SERVICE INSTRUCTION

RUNNING MODIFICATIONS ON

ROTAX® ENGINE TYPE 912/914 (SERIES)

SI-912-020R7

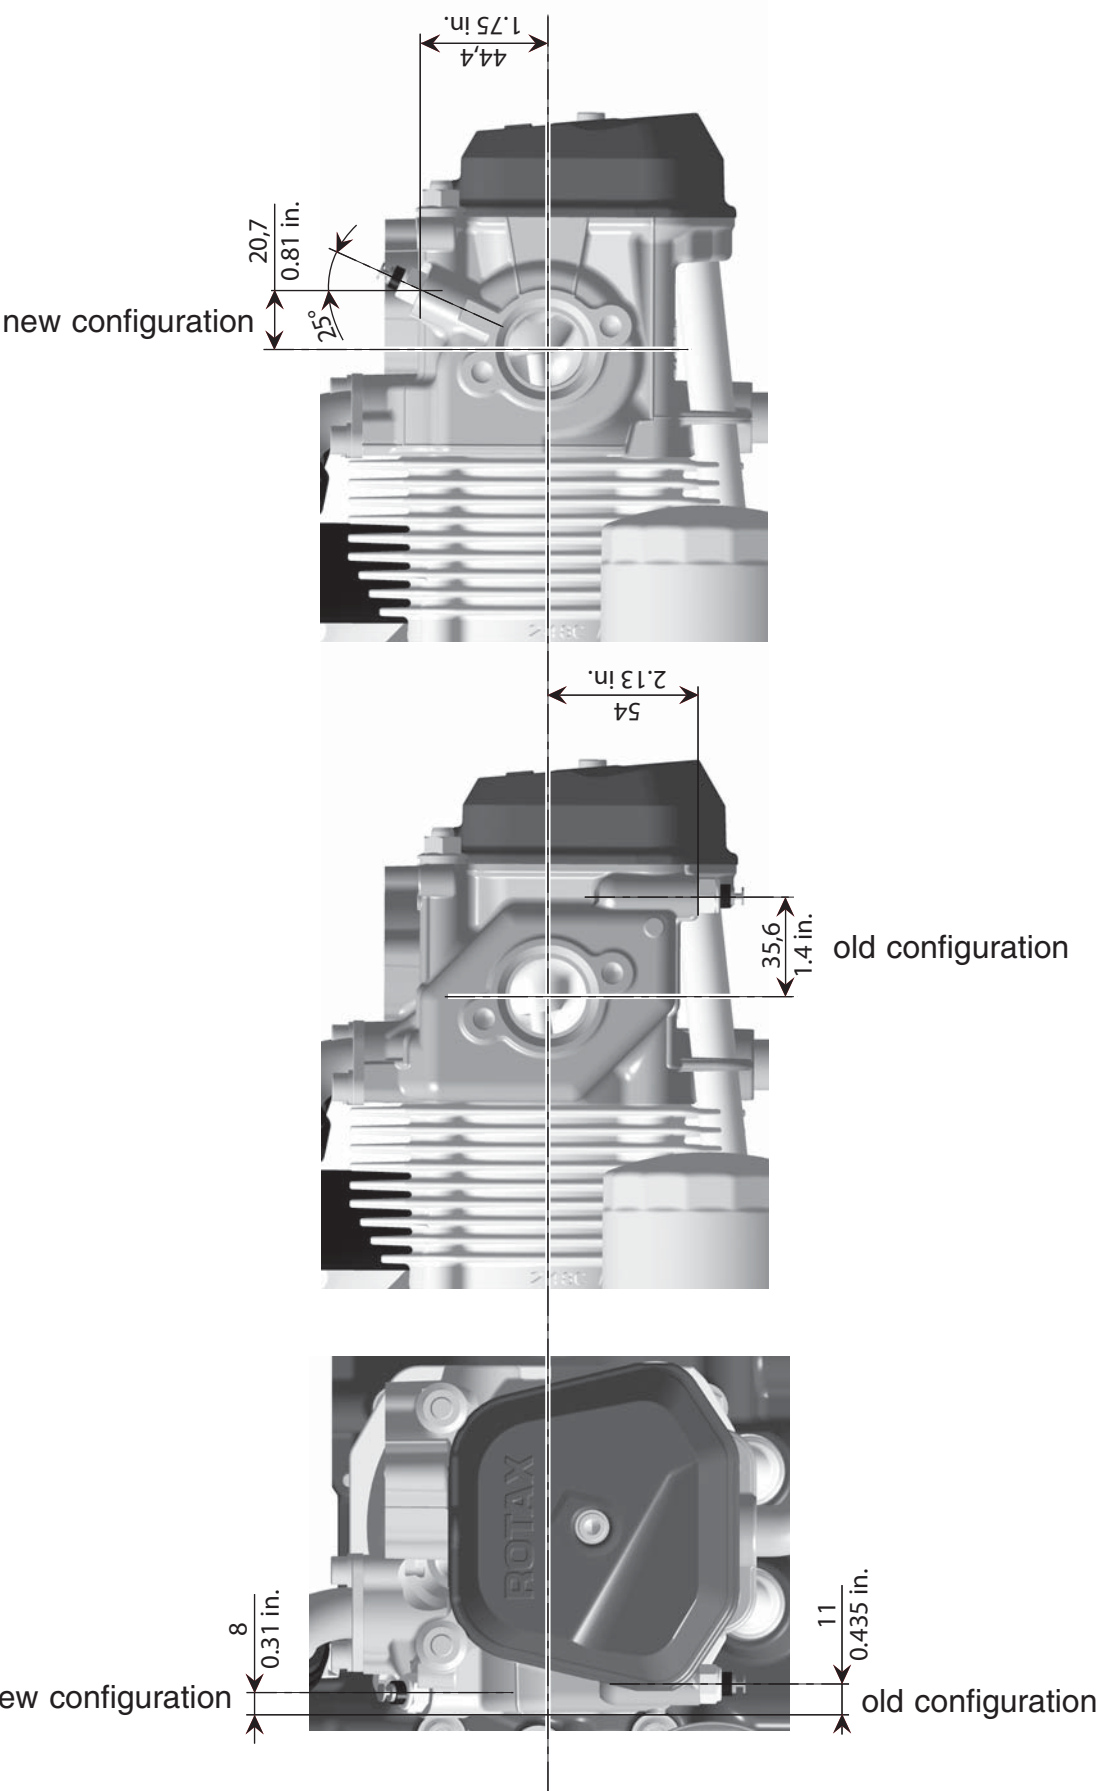
In case of a retrofitting/repair or overhaul, observed the installation and maintenance related changes, since specifically changes in the cylinder head temperature sensor position and thus a change of the wiring is necessary. Proof of certification to the latest requirements such as FAR or EASA has to be supplied by the aircraft manufacturer.

Regarding change of position see fig. 1.

- ◆ NOTE: Contrary to the current design, the temperature sensor is directly flooded with coolant. Therefore the thread must be sealed with LOCTITE.

1. Clean the thread of the temperature sensor.
2. Apply LOCTITE 243 to the thread of the temperature sensor. Tightening torque 10 Nm (90 in.lb).
3. Plug the respective wiring harness connector into the temperature sensor.

fig. 2

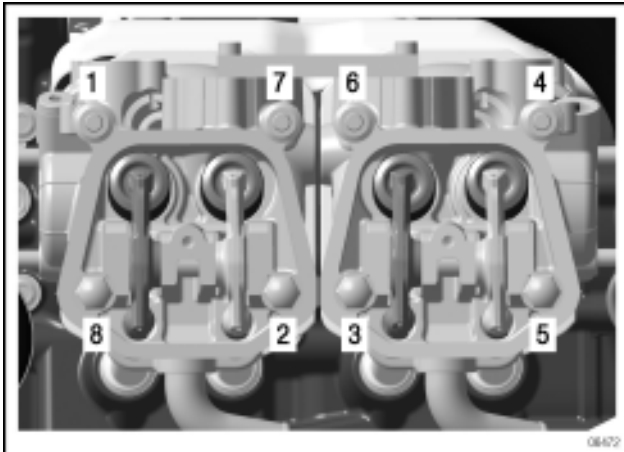
2) Change of the tightening torque procedure for the installation of the cylinder heads

In the course of continuous development a new tightening torque procedure for the installation of the cylinder heads has been introduced.

1. Fasten the cylinder finger-tight and diagonally at first with M8 collar cap nuts and M8 hex. nuts.
2. Fasten the cylinder heads according to the diagonal torque pattern show in fig. 2.

Tightening torque 10 Nm (90 in.lb) + 120°.

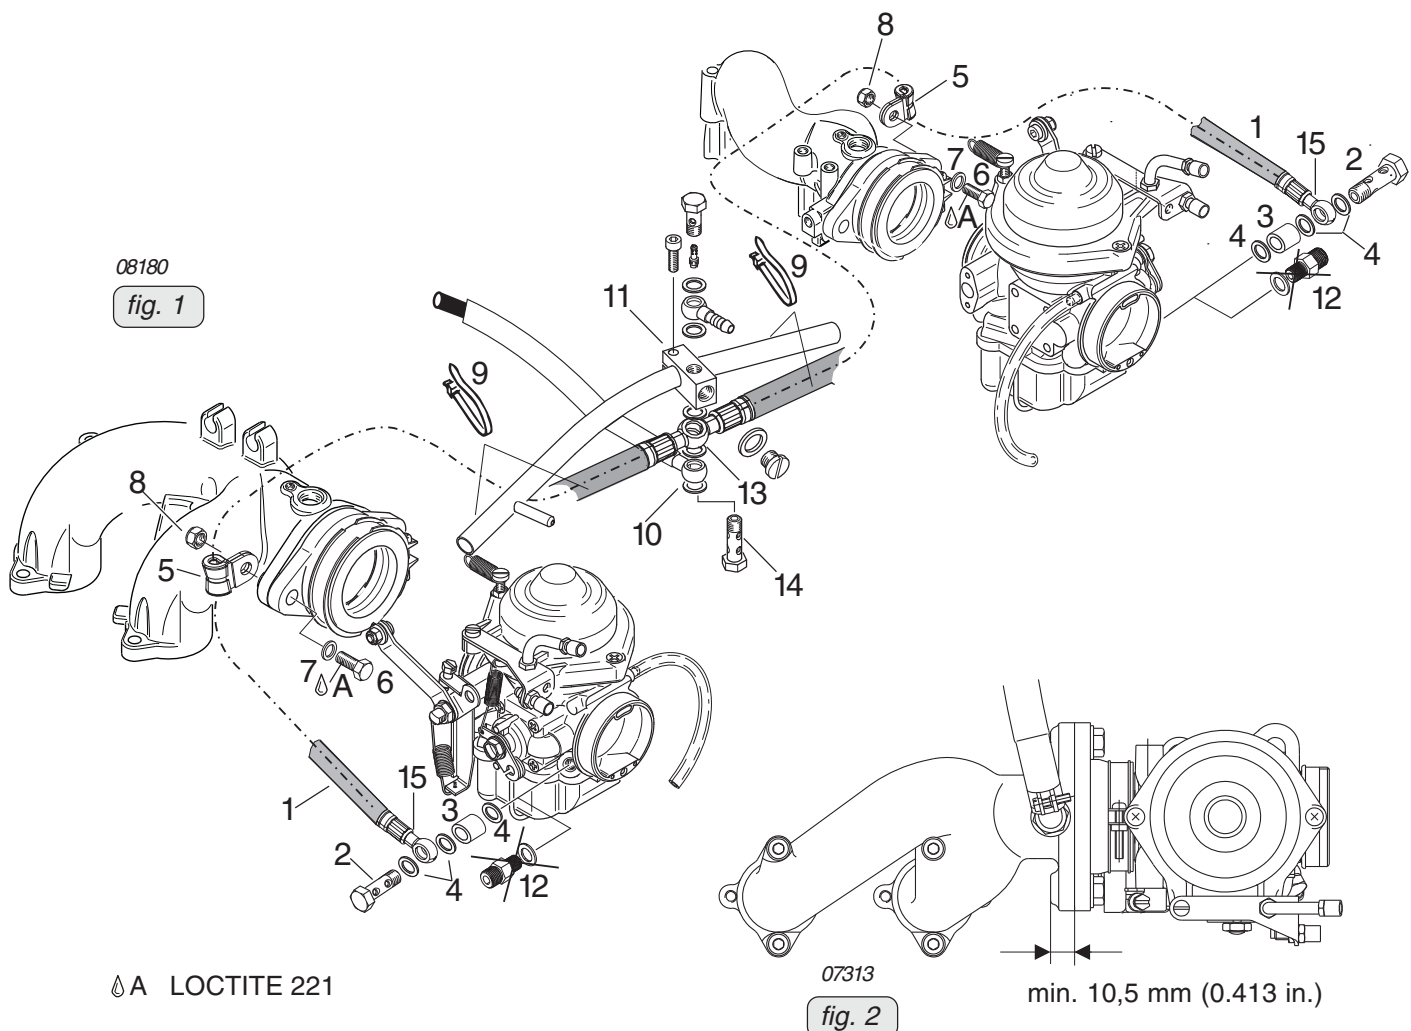
In the course of continuous development and for better assembly and maintenance a new flexible fuel line (part no. 874911) has been introduced.

- mechanical machining at the intake manifold for the attachment of the cable clamp. At engine repair/general overhaul be aware that the fixation of the flexible fuel line needs an appropriate contact surface. If necessary replace the intake manifold or machine the contact surface according to the following instruction.

- Install the flexible fuel line (1) with the double ring hose nipple (13) and sealing ring (10) on the clamp block (11). Tightening torque of banjo screw (14) 10 Nm (90 in. lb.) (see fig. 1).
- Install the ring hose nipple (15) with distance sleeve (3) and sealing ring (4) on the carburetors. Tightening torque of banjo screw (2) 10 Nm (90 in. lb.)

- For installation on an old style intake manifold perform the following: Remove the intake manifold and machine the nut/clamp contact area until the surface is parallel with the sealing surface of the carb socket. The thickness of the material must not be dressed down less than 10,5 mm (0.413 in.) and should be smooth and flat so that the nut/clamp assembly has an even contact surface (see fig. 2).
- Ensure proper support of the flexible fuel line. Install Hex. screw (6) and washer (7) with 15 Nm (133 in. lb.). Install the cable clamp (5) at the hex. screw (6) of the carburetor socket with the hex. nut (8). Tightening torque of hex. nut (8) 24 Nm (213 in. lb.)

■ **CAUTION:** While tightening hex. nut (8), hold hex. screw (6) with a wrench to prevent it from loosening. Always fix the flexible fuel line at the compensation tube with clamps (9) in such a way that no wear is possible.

08353
fig. 1

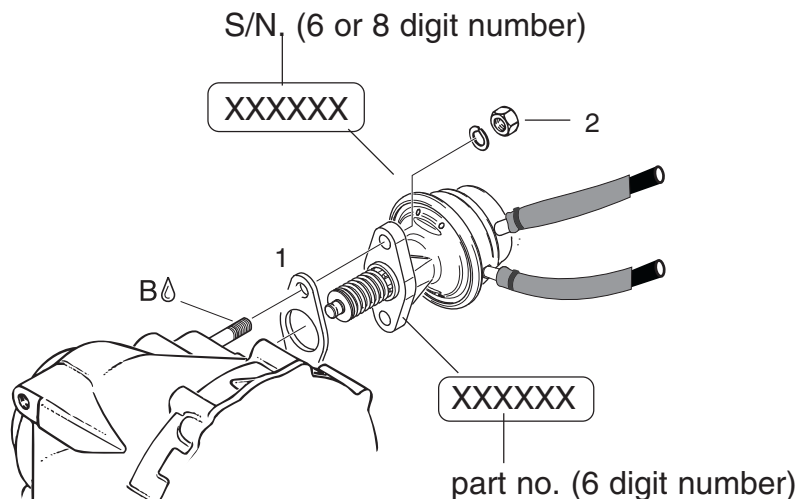
In the course of continuous development a new gasket (1) (part no. 950226) has been introduced.

- ◆ NOTE: On the sealing surfaces of the gearbox housing and the fuel pump no sealing compound has to be used.

fig. 1

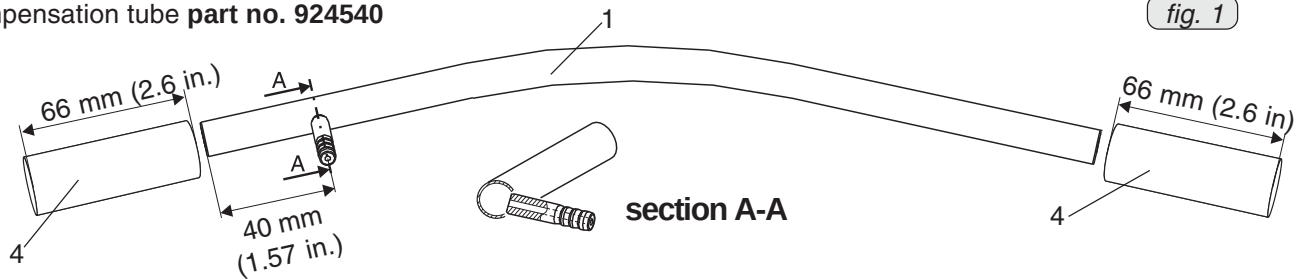
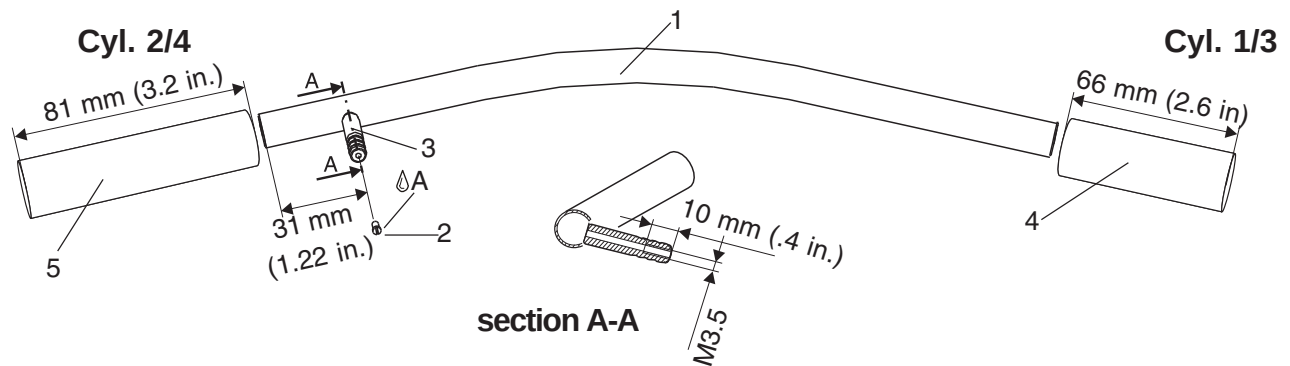
In the course of continuous development a new compensation tube (1) (part no. 924541) has been introduced which the synchronization to make it easier, the tube must not removed.

- position of connection fitting (3) on compensation tube remains approximate constant
- additional screw (2) part no. 940980 for connection fitting (3)
- new tube (4) part no. 956143 (5) part no. 956141

fig. 2

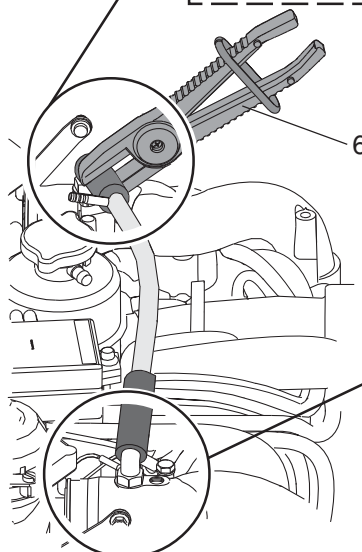
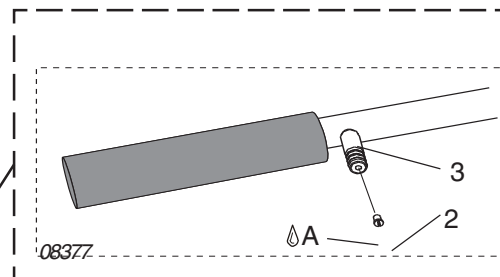
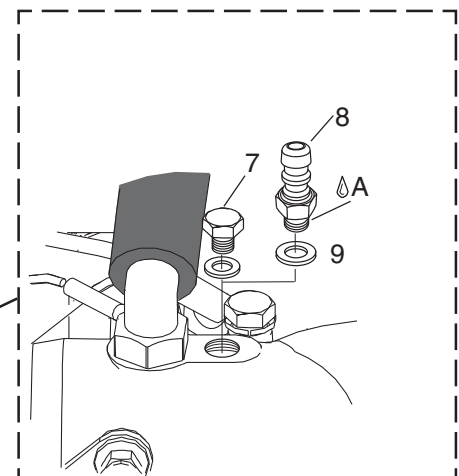
additional variant (taking advantage of the new compensation tube):

1. Install the vacuum gauge.
2. Clamp the tube with hose clamping pliers (6). Observe the position! The tube (1) must not removed.
3. Unscrew the screw (7).
4. Install the hose nipple M6 (8) with the sealing ring (9).
5. After synchronization tightened the screw M6x6 (7) with LOCTITE 221.

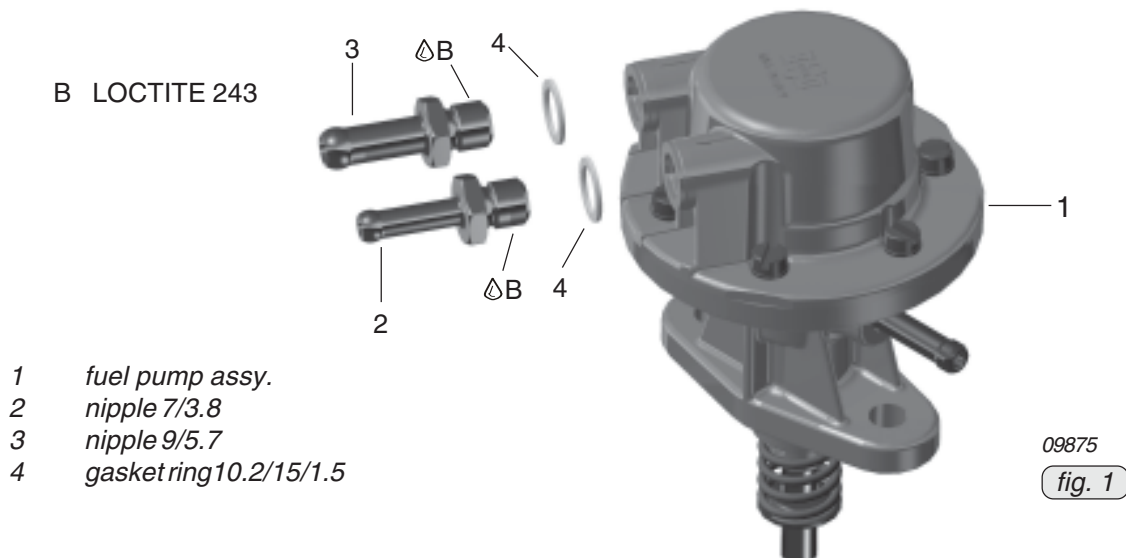
4.2) Retrofit of fuel pump assy. part no. 893110 to part no. 893115

Pump inlet (3):

nipple..... 9/5.7
tightening torque..... 10 Nm (90 in.lb)

Pump outlet (2):

nipple 7/3.8
tightening torque..... 10 Nm (90 in.lb)

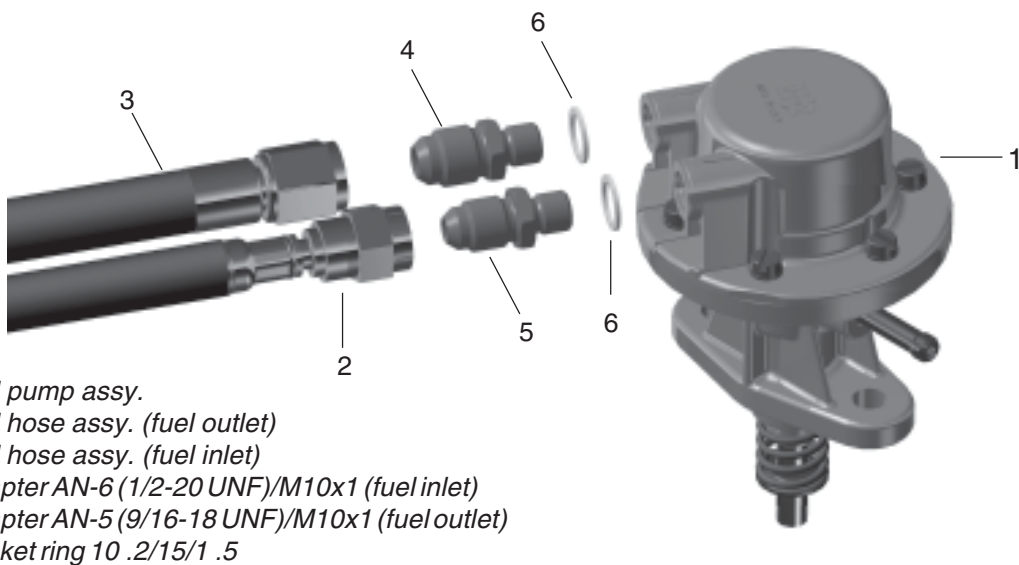
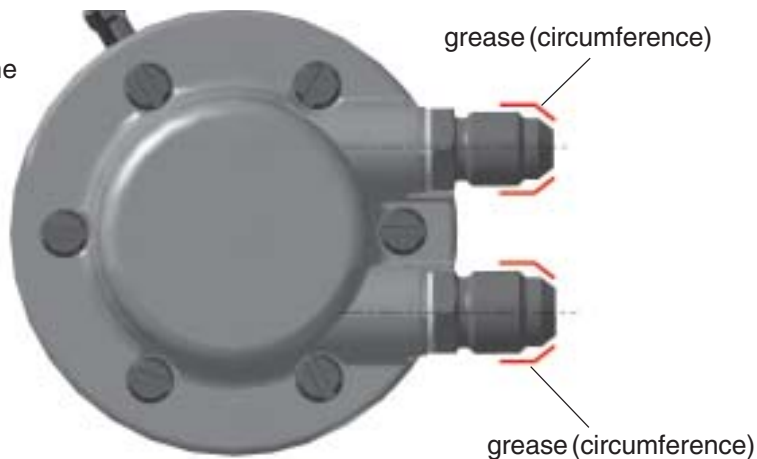
4.3) Retrofit of fuel pump assy. part no. 893114 to part no. 893115

Connecting fuel hoses to adapter:

tightening torque..... 32 Nm (23.6 ft.lb)

tightening torque..... 27 Nm (20 ft.lb)

■ CAUTION: Counterhold the adapter during tightening.

08829
fig. 3

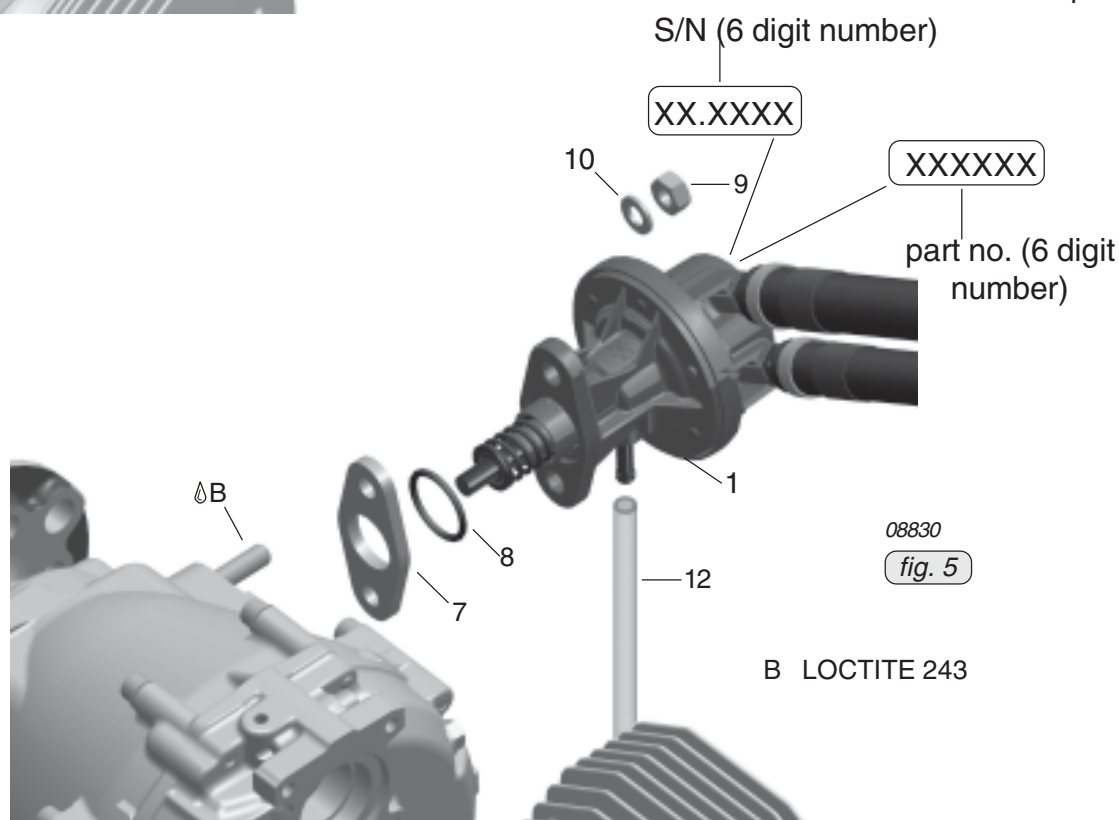
Option 1

Connecting to fuel pump (1) with push-on fittings. See fig. 3.

Pump inlet (2):

outside dia..... 8 mm (0.31 in.)

slip-on length for hose attachment: max. 22 mm (0.87 in.)

Pump outlet (3):

outside dia..... 6 mm (0.25 in.)

fig. 1

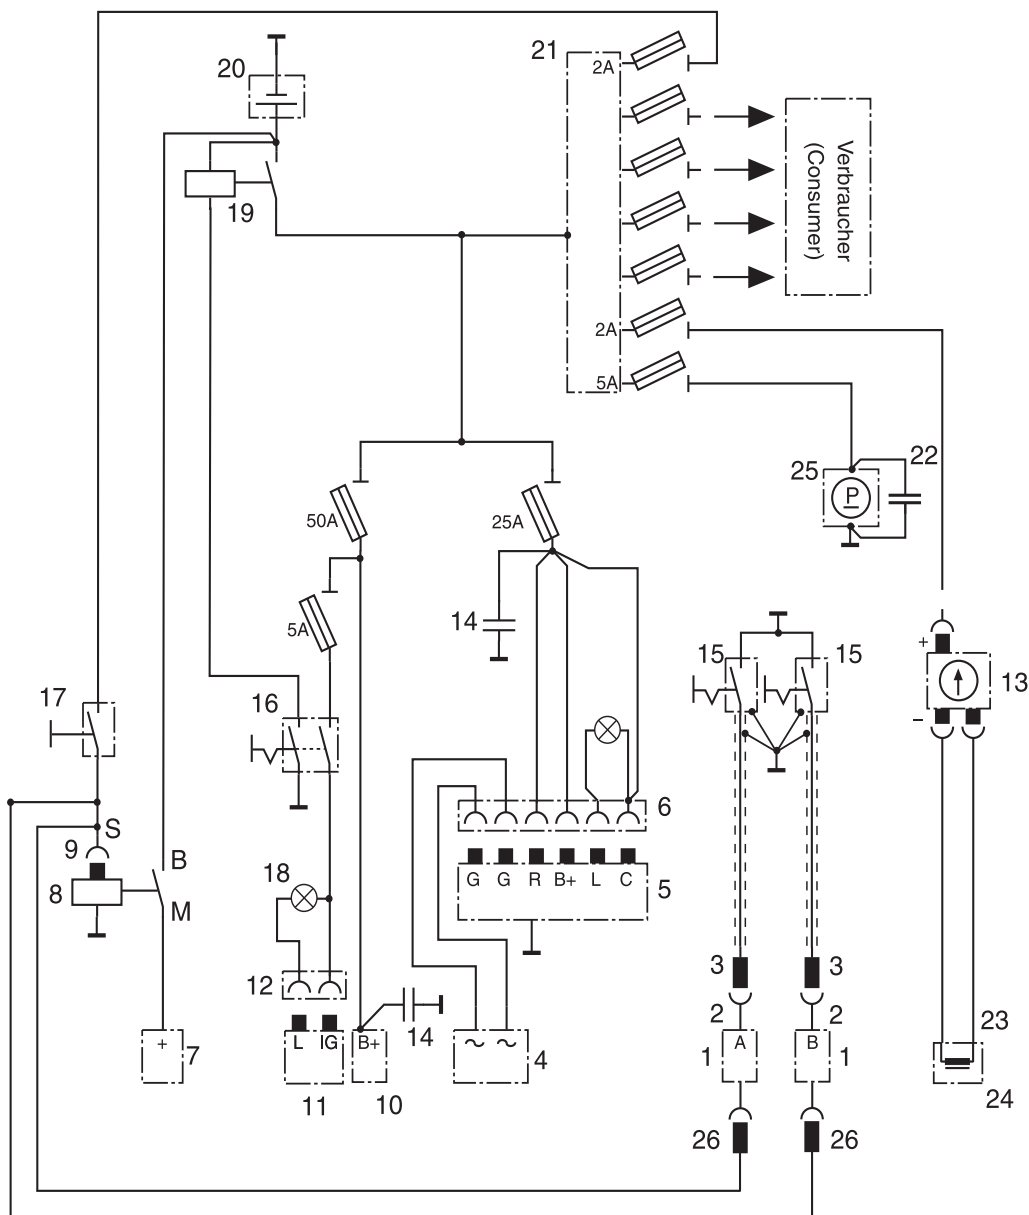
In the course of further development and standardization an electronic module for delayed start up ignition timing has been introduced. This module can be activated by a 12 V signal. Without this optional 12V activation the function works the same way as on the well-proven previous module.

- 1 wire of each module circuit A and circuit B (6-pole) to start relay control signal wire (see position 26 in fig. 1) must be supplied by the aircraft manufacturer. Therefore the rubber plug of the pin terminal must be removed before!
- Time factor for delaying ignition timing at start until switching to advanced ignition: After starting the engine and as soon as the starter/relay is not powered anymore, the engine continues to further run for 3-8 seconds with delayed ignition.
- Do not connect the signal wire to the electric starter motor - as the circuit has not voltage protection.
- Do not power the advanced start terminal permanently with 12V. The delay timer function would be bypassed and charging speed might vary (depending on internal tolerances, trigger gap etc.).
